# Product/Process Change Notice (PCN)

PCN #: ConUSB\_20150915  
Product Affected: 65100516121

PCN Date: September 29<sup>th</sup>, 2015  
Effective Date: December 29<sup>th</sup>, 2015

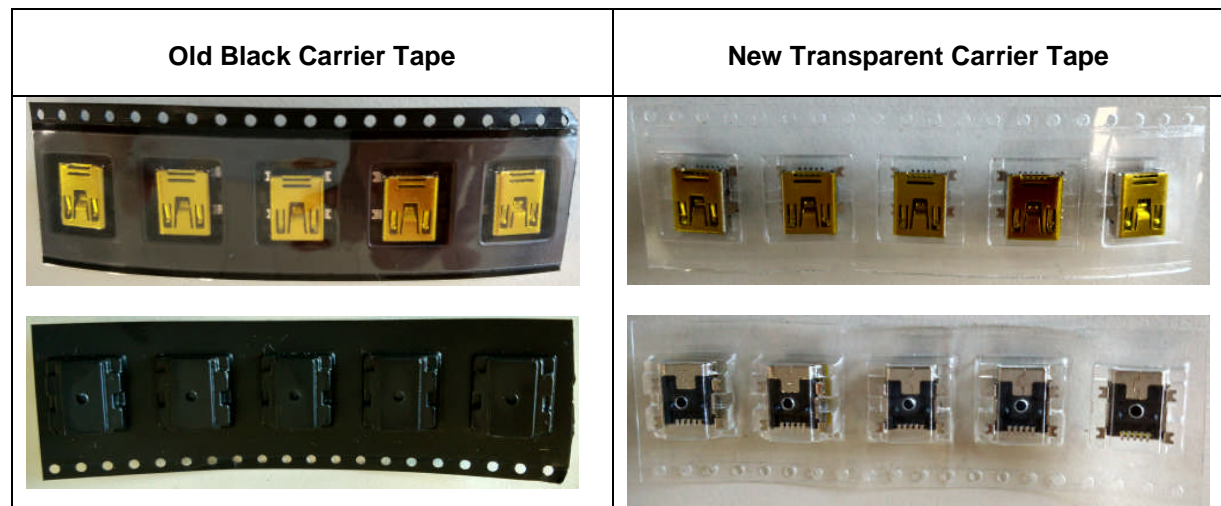
For process improvement purposes, Würth Elektronik will change the colour of the carrier tape.

The carrier tape will be changed from black to transparent colour, facilitating the optical inspection.
